ARCHITECTURAL REVIEW BOARD WORK SESSION AGENDA

Agenda Item: Discussion - Pre-application - 13100 & 13150 Worldgate Drive

MEMORANDUM

Subject: Pre-application ARB case, 13100 & 13150 Worldgate Drive

Figure 4: Detail showing soldier-course brick lintels and double hung windows proposed for the stacked condos.

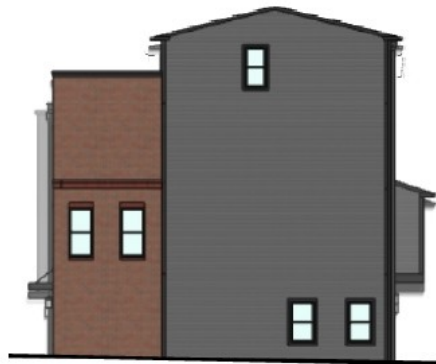
Change from Contemporary to Traditional Design Elements. The new design introduces traditional design features such as double hung windows with soldier-course brick lintels and a gable roof, that are inconsistent with the contemporary nature of the proffered design and contemporary design of the multi-family building (Figure 4; Figure 5). The comments below go into more detail about how these changes are impactful to the overall design. Maintaining a consistent contemporary design will be important for retaining a cohesive design narrative between both phases of this development.

Figure 9: Proposed revisions to the side elevations for the stacked condos (left) and the townhouses (right).

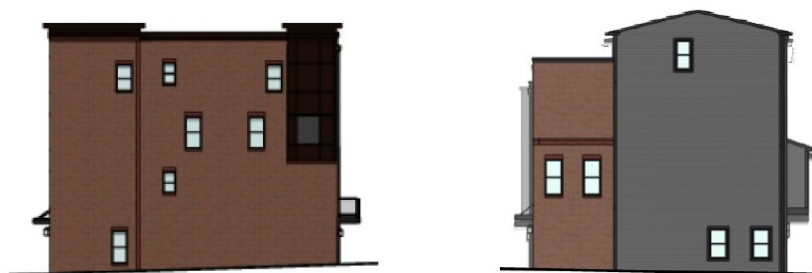
Elevation Solid to Void Ratio. The new design and fenestration results in more solid wall space and less opening area (Figure 2; Figure 3). This is due in part to the loss of the large window groupings and is particularly problematic on the side elevations (Figure 9).

Side Elevation Design. The side elevations of these buildings lack a clear four-level component found in the proffered elevations and the decreased fenestration creates an imposing feeling from the surrounding pedestrian areas (Figure 9). The overall window area is decreased in the revised designs of both the townhouses and the stacked condos, resulting in window arrangements that lack formal cohesiveness with the front

Figure 2: A comparison of how the deep cornice of the above building (located at 1111 Belle Pre Way, Alexandria, VA 22314) appears from across the street (left) and from the sidewalk adjacent to the building (right). Note that the deep cornice visually minimizes the height of the upper floor.

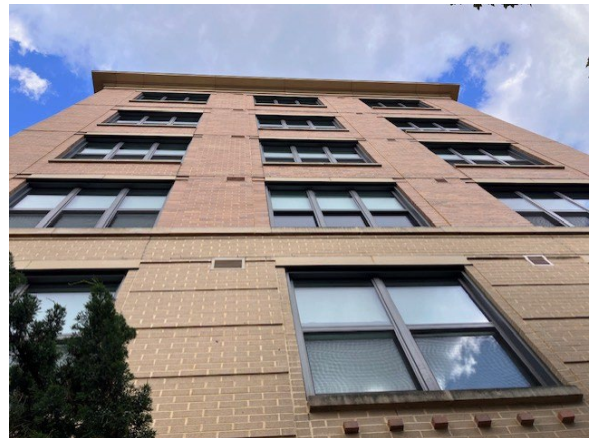
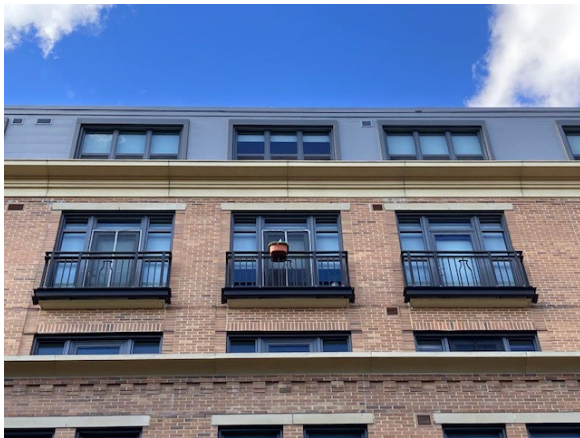
Staff assert that the changes proposed in this design generally move beyond cosmetic tweaks and demonstrate meaningful formal and material alterations in response to the ARB's and staff's previous comments. However, staff hold that the applicant needs to address the question of adequate step-back above 40' to adequately meet the related guidelines in the TRG plan. This could be done through the use of deeper or thicker cornice materials and detailing of the pediment to visually trick the eye (Figures 1-2). Furthermore, staff recommend that the applicant employ a greater variety of materials along the Herndon Parkway elevation to further break up the massing along this façade.
